# **ISSUE RESOLUTION STATUS REPORT**

**KEY TECHNICAL ISSUE:  
EVOLUTION OF THE NEAR-FIELD ENVIRONMENT**

**Division of Waste Management  
Office of Nuclear Material Safety & Safeguards  
U.S. Nuclear Regulatory Commission**

**Revision 3**

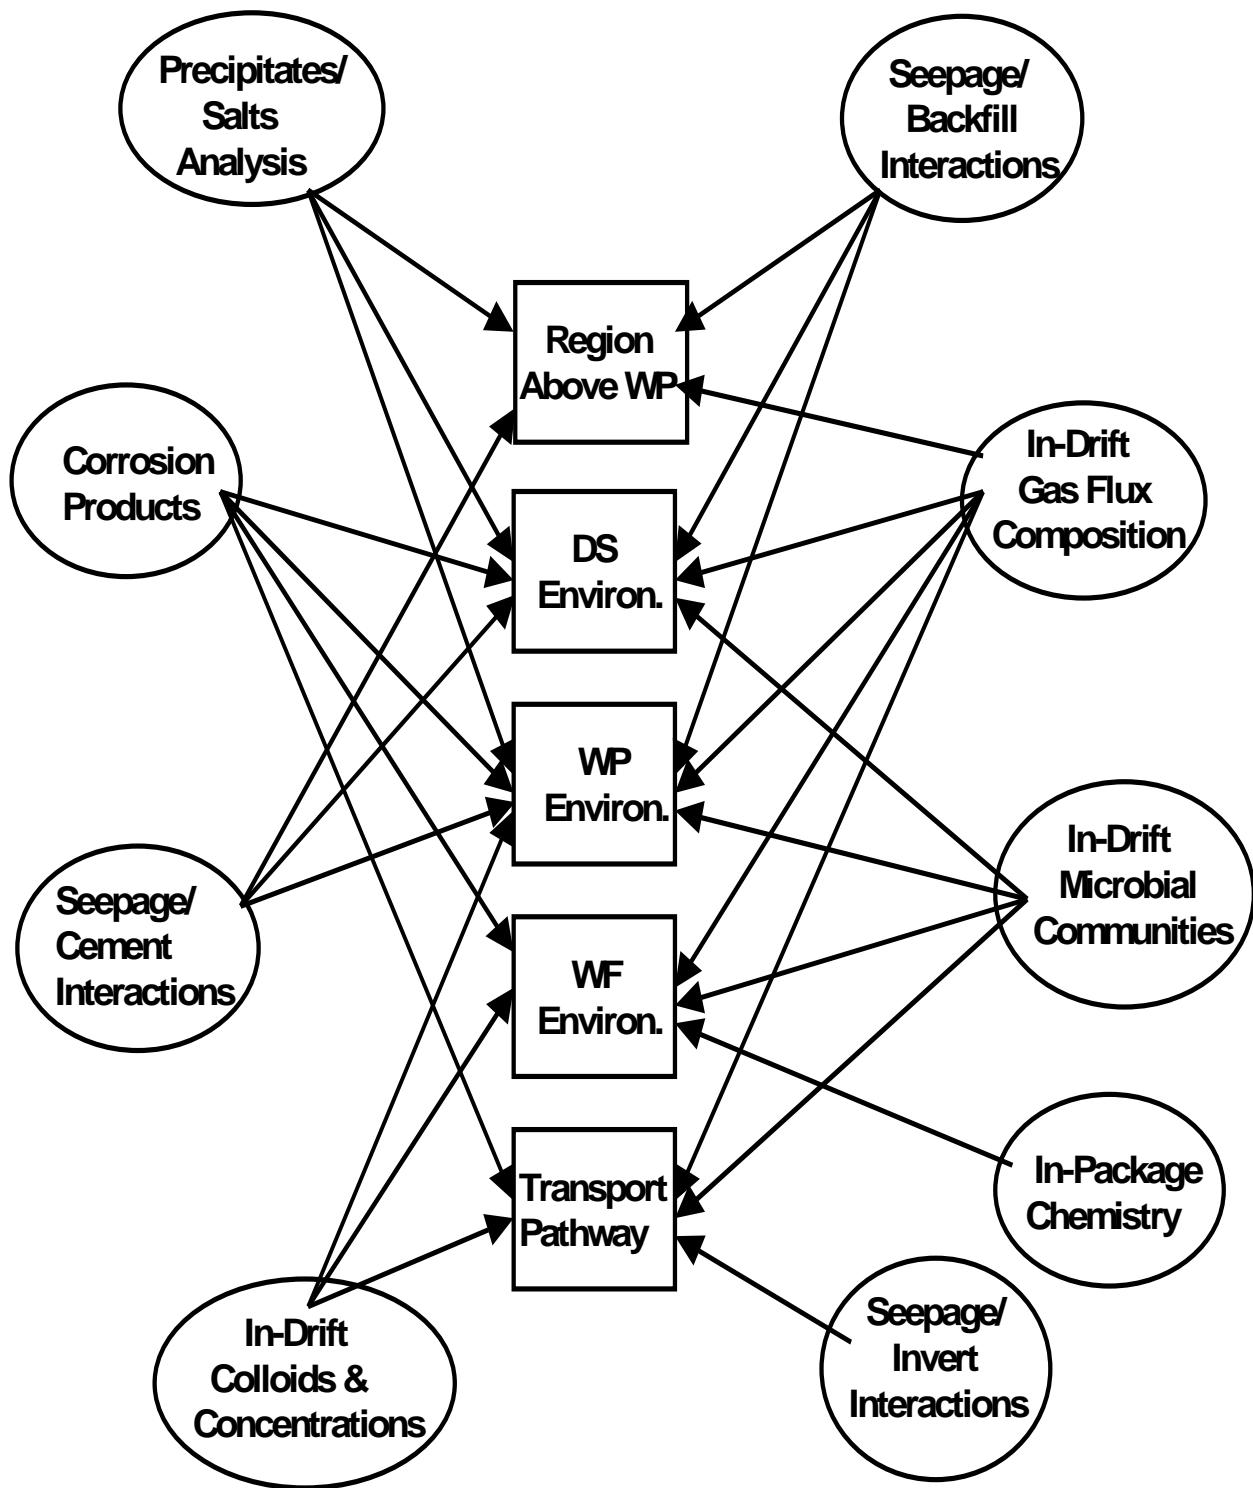
The approach used in the TSPA-VA (U.S. Department of Energy, 1998b) will be modified for the TSPA-SR to refine abstractions and process-level models, to take into account the potential effects of the new repository design, and to improve coupling between abstractions. Figure 5-1, taken from the TSPA-SR methods and assumptions report (CRWMS M&O, 1999a), shows the basic architecture of the new DOE approach. The TSPA-Site Recommendation conceptual model includes five spatial domains that are linked together by a flow pathway. The spatial domains, sometimes referred to as repository integration program (RIP) cells are (i) the backfill region above the drip shield, (ii) the drip shield environment, defined as the backfill region immediately on or adjacent to the drip shield, (iii) the waste package environment, defined as the region immediately on, or adjacent to, the waste package (this region includes backfill, invert, or corrosion products), (iv) the waste form environment, which includes the interior of the
